37/3-prelim 7501 Carroll Avenue
Takoma Park Historic District

HISTORIC PRESERVATION COMMISSION STAFF REPORT

Address: 7501 Carroll Avenue Meeting Date: 10/13/93
Resource: Takoma Park Historic District Preliminary Consultation
Case Number: n/a Tax Credit: No
Public Notice: 9/29/93 Report Date: 10/6/93
Applicant: C. Highsmith/T. Landfair Staff: Nancy Witherell
PROPOSAL: Construct rear addition RECOMMEND: Proceed

2 FLOOR PLAN

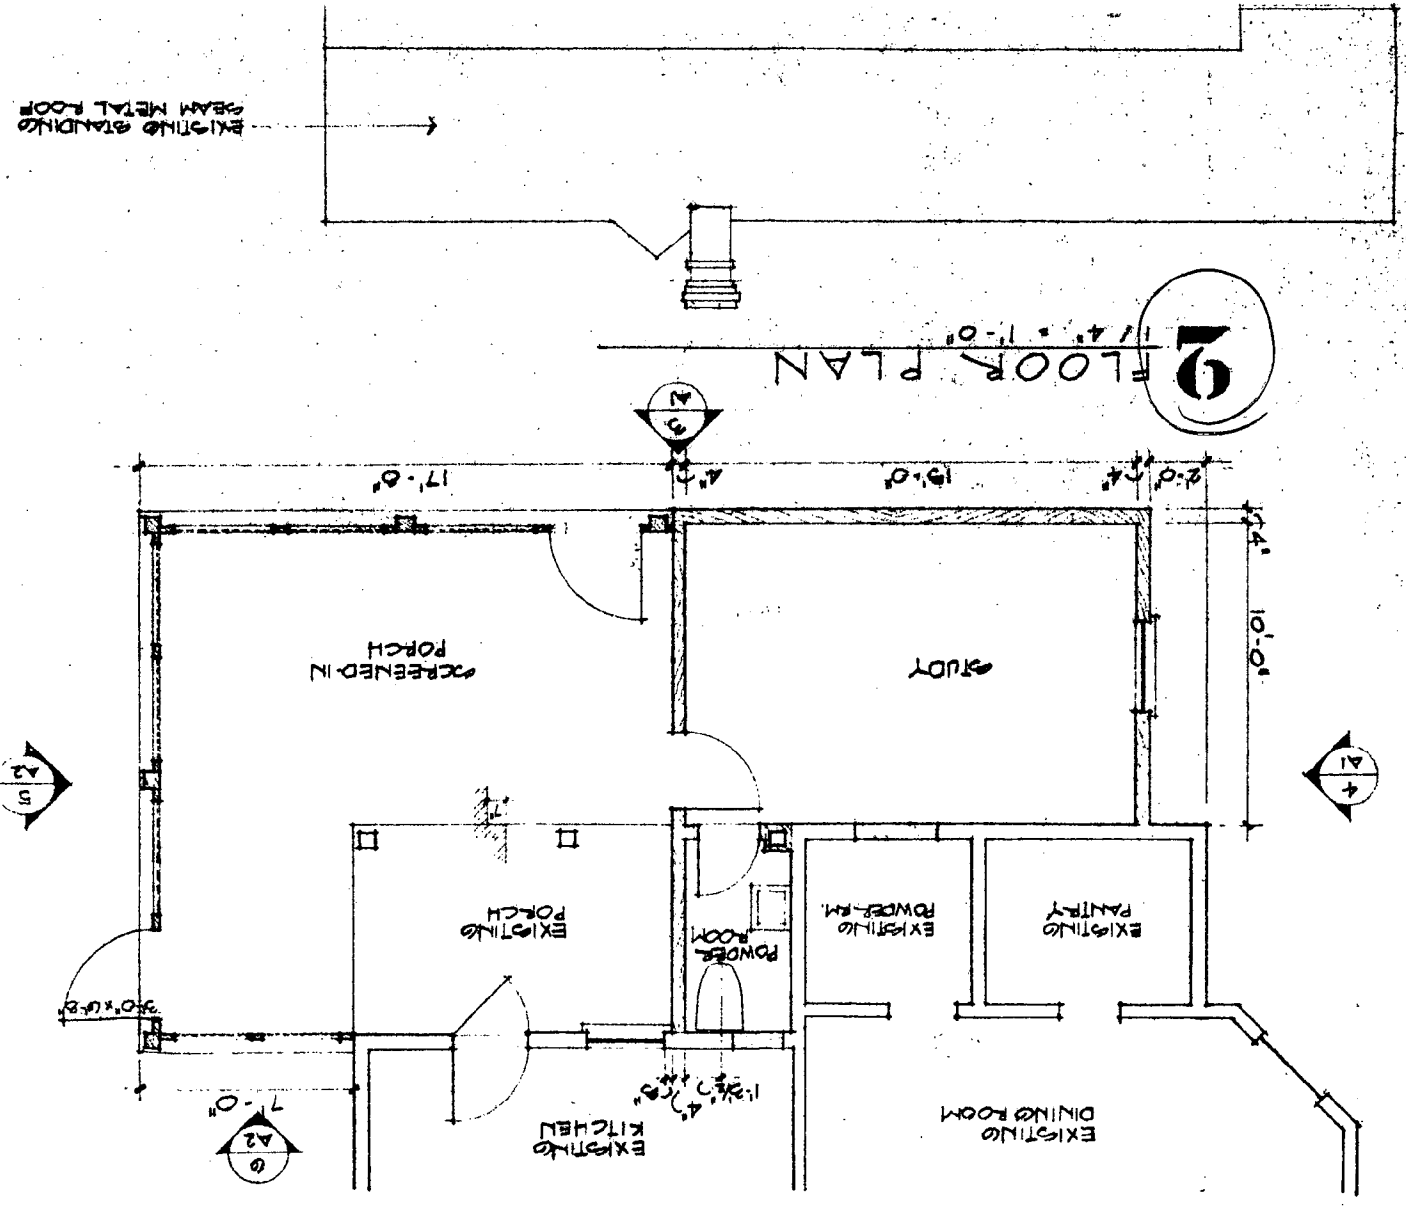
In the staff's judgment, the scale and placement of the new construction is sensitively designed. The one-story study addition is small in scale and the slope of the shed roof falls naturally from the rear elevation. The screened porch projects to the side (beyond the width of the house) but is, by its nature, less obtrusive than it would be as a solid mass. It wraps to the point where it would incorporate the existing open one-story porch but would not affect the nearby window openings.

3 REAR ELEVATION
114' x 110'

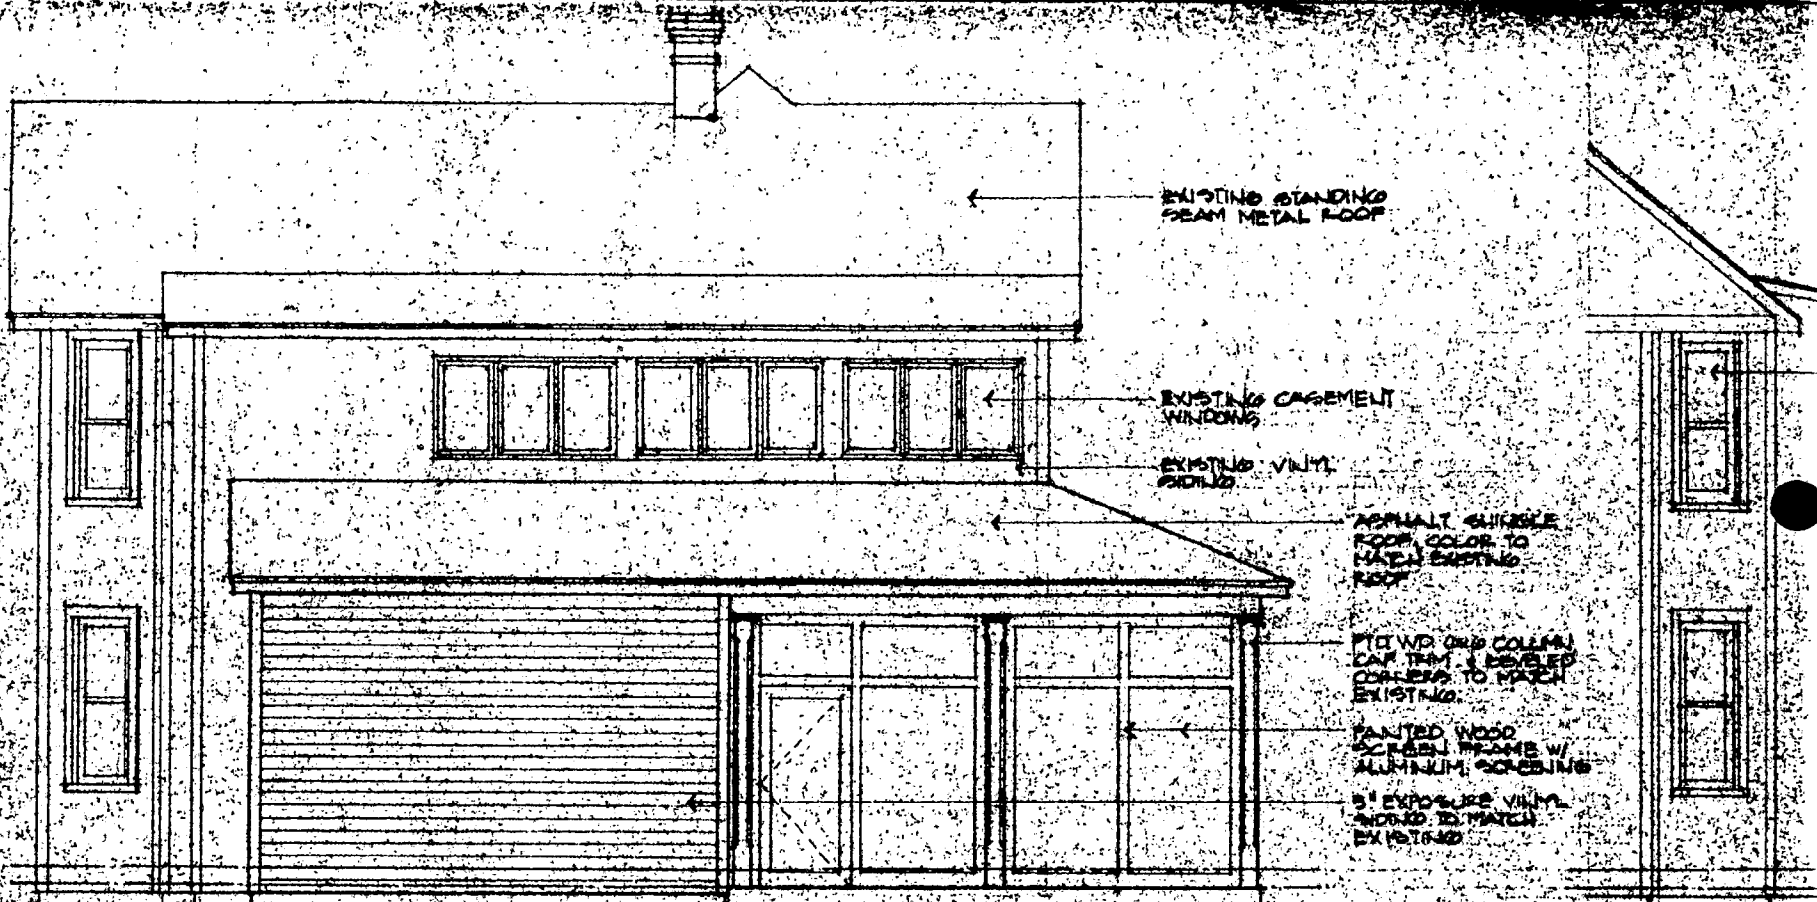
As the house is entirely clad with vinyl, the staff concurs with the applicants' proposal to use the same material on the addition. The staff would suggest, however, that the new roof be standing seam to match the existing roof, particularly since it

is a prominent feature of the house on its corner lot and the new roof will be visible, as well.
